ADDENDUM NOTE: THIS ADDENDUM HAS BEEN CREATED TO DELETE THE DROP INLET AND TO ADD A SIDEWALK CULVERT AS SHOWN HEREON.

DRAINAGE AND GRADING PLAN
SANDIA PEAK INN

12-09-05
 ADDENDUM 4/24/2007

Project: 18 Guestroom Addition to Sandia Peak Motel
 Kanak P. and Pratap Yadav
 Albuquerque, New Mexico

C1

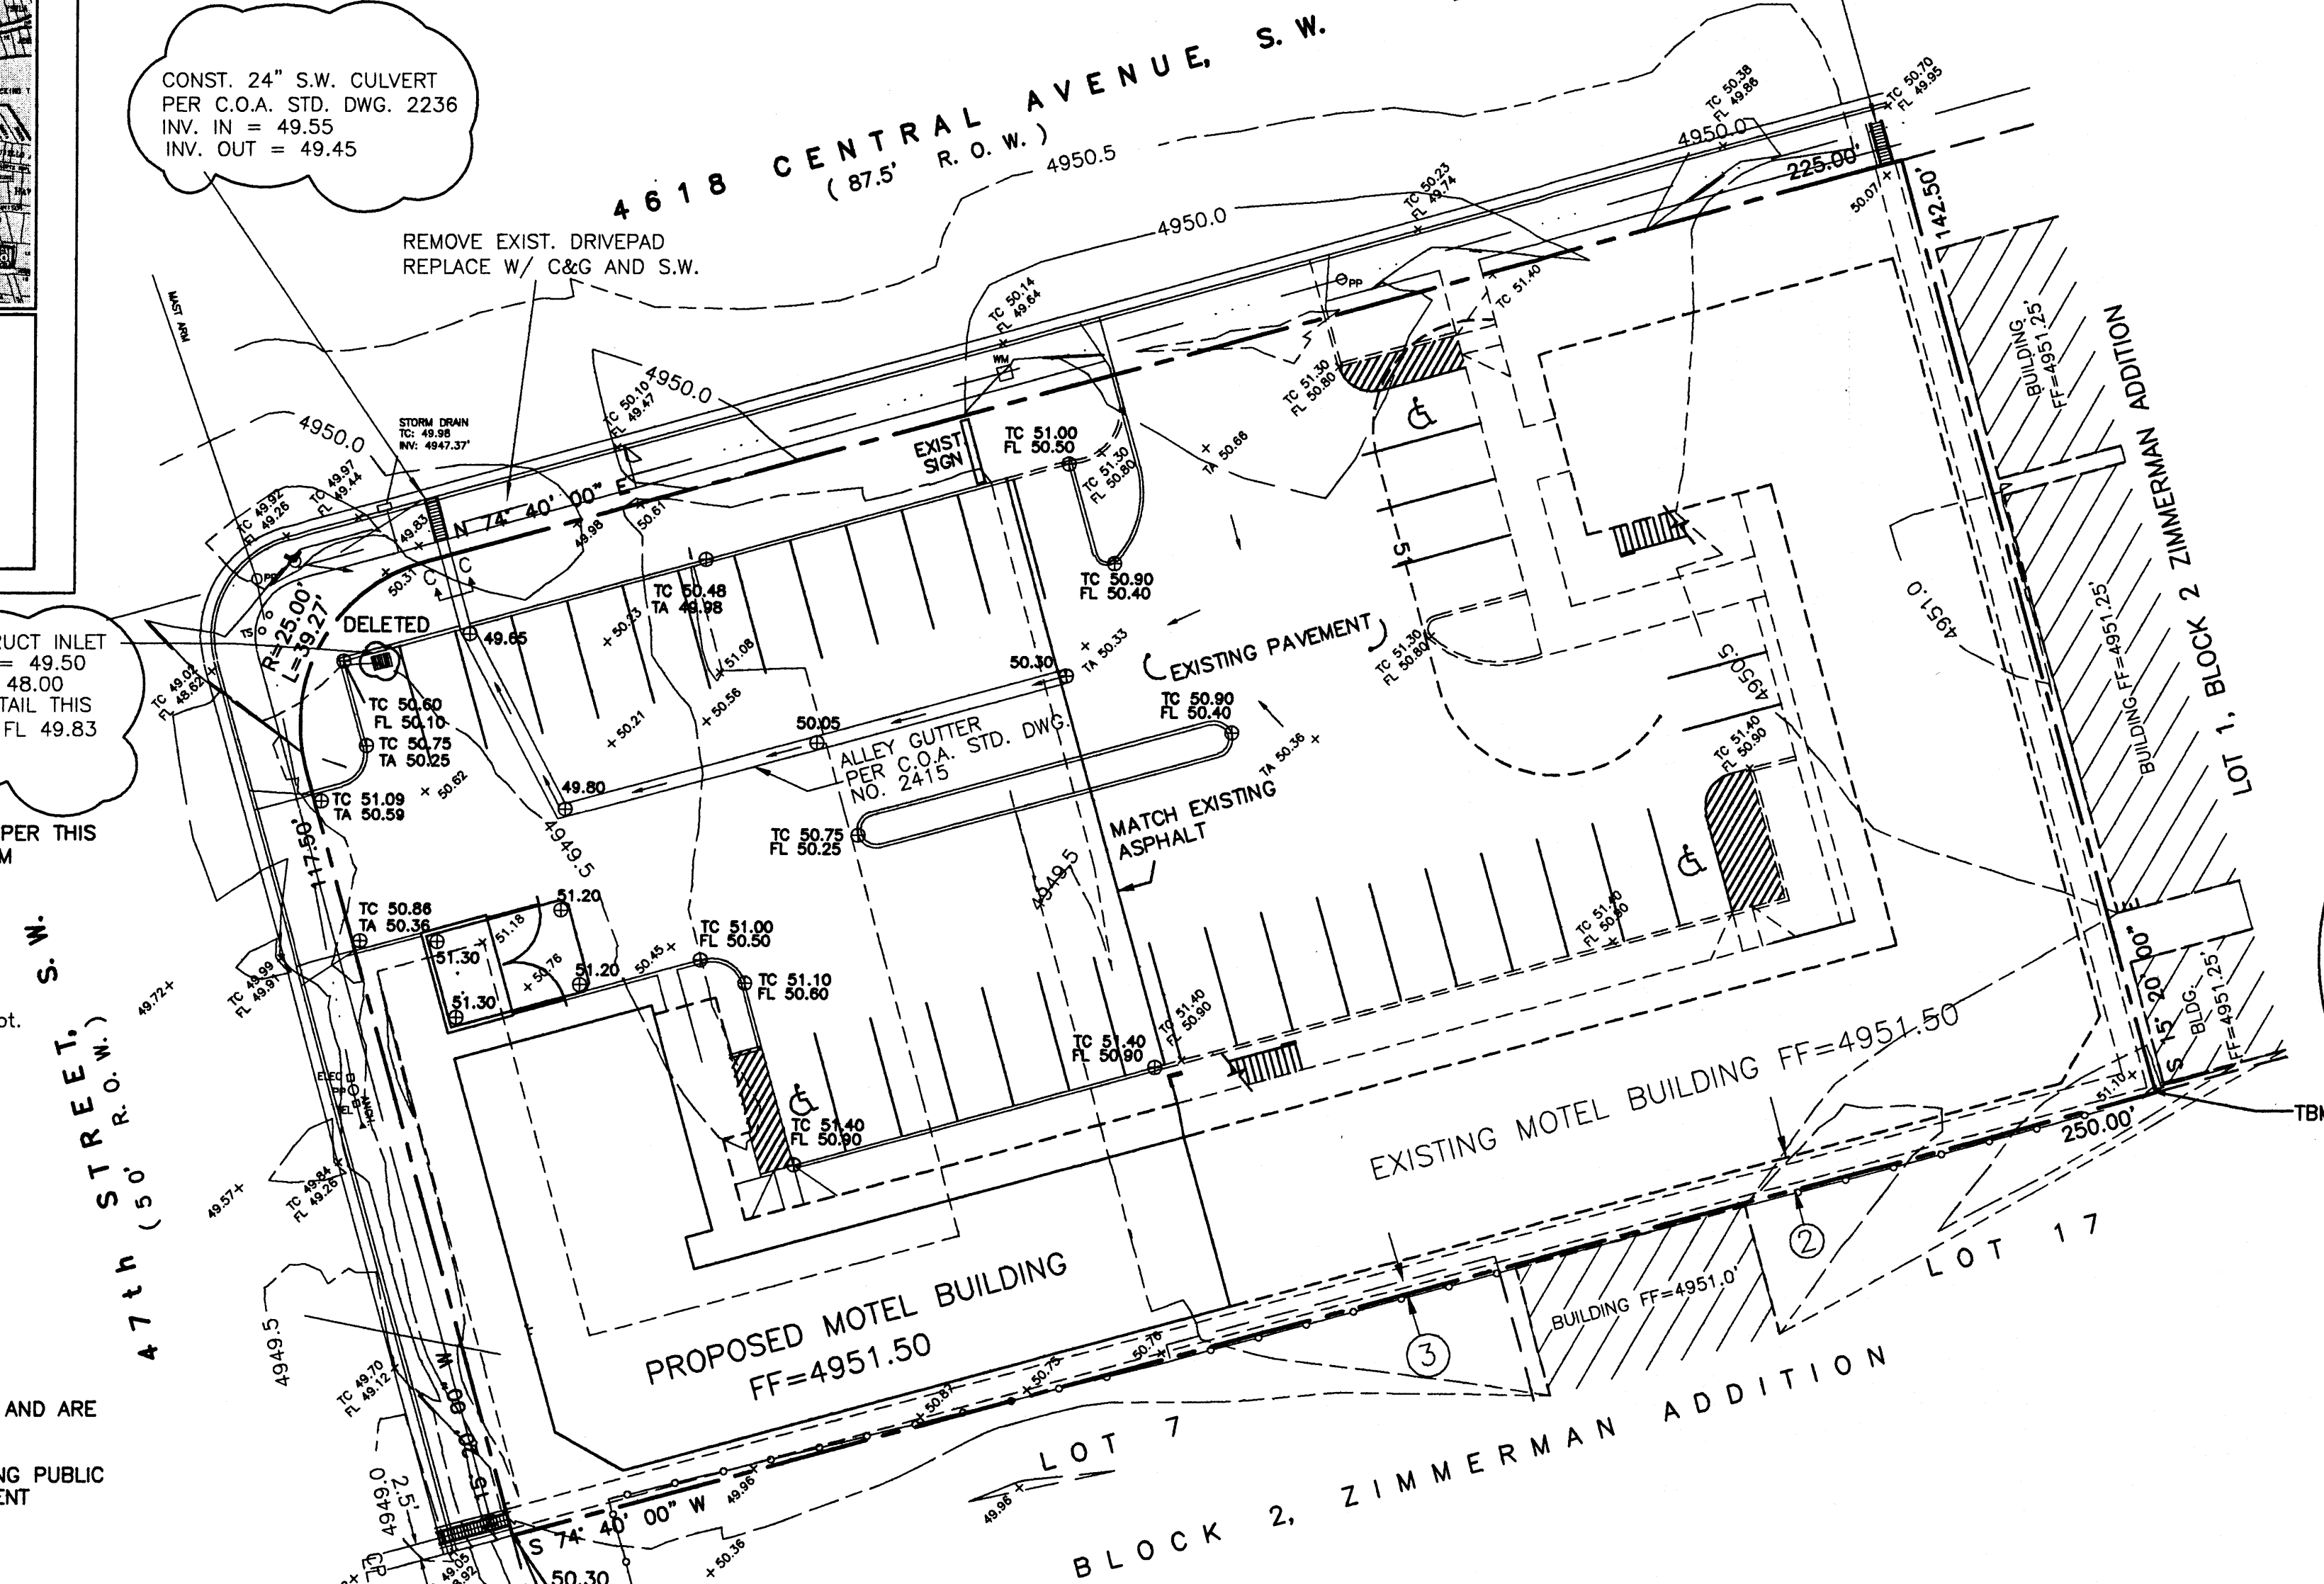
ADDENDUM NOTE: THIS ADDENDUM HAS BEEN CREATED TO DELETE THE DROP INLET AND TO ADD A SIDEWALK CULVERT AS SHOWN HEREON.

ADDED PER THIS ADDENDUM

REMOVE EXIST. DRIVEPAD
REPLACE W/ C&G AND S.W.

CONSTRUCT INLET
GRATE = 49.50
INV. = 48.00
SEE DETAIL THIS
SHEET. FL. 49.83

Sheet
C1

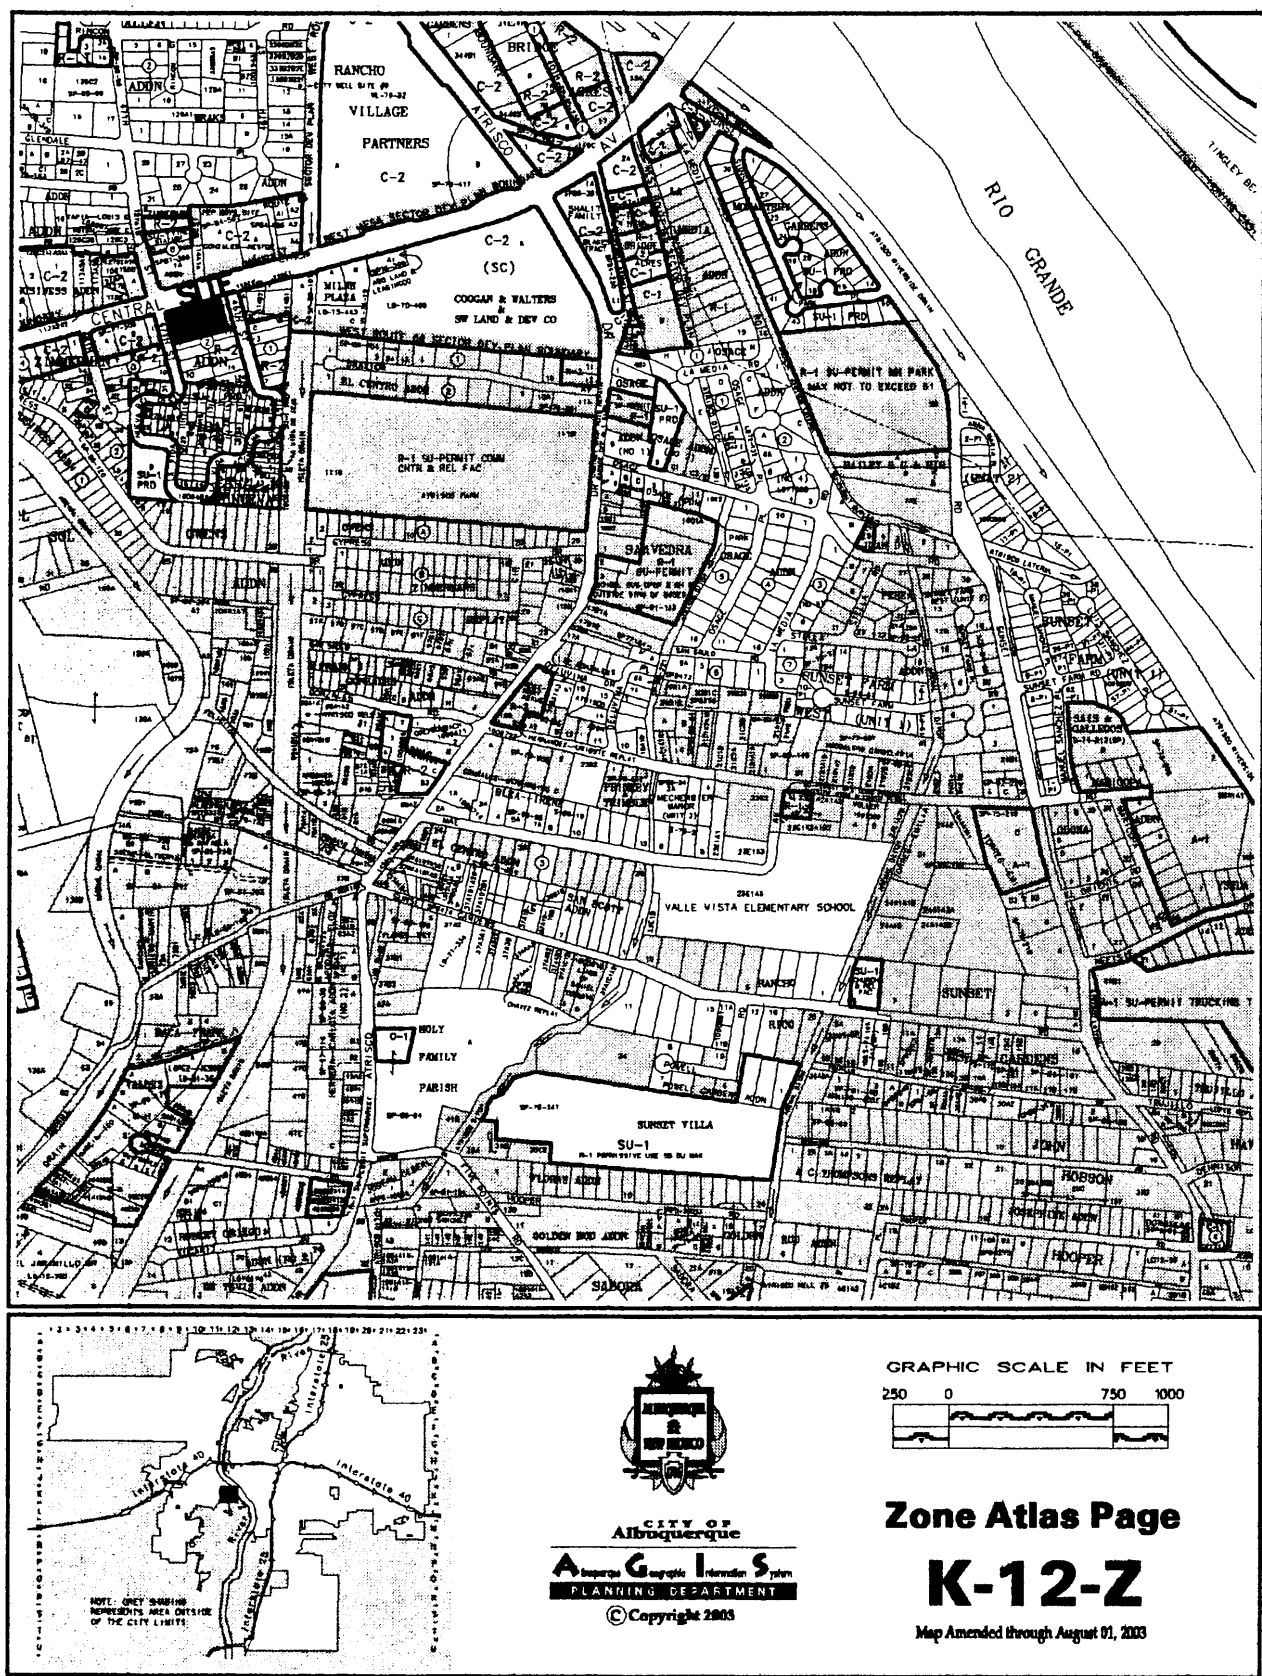
ADDENDUM NOTE: THIS ADDENDUM HAS BEEN CREATED TO DELETE THE DROP INLET AND TO ADD A SIDEWALK CULVERT AS SHOWN HEREON.

ADDED PER THIS ADDENDUM

REMOVE EXIST. DRIVEPAD
 REPLACE W/ C&G AND S.W.

CONSTRUCT INLET
 GRATE = 49.50
 INV. 48.00
 SEE DETAIL THIS SHEET.
 FL 49.83
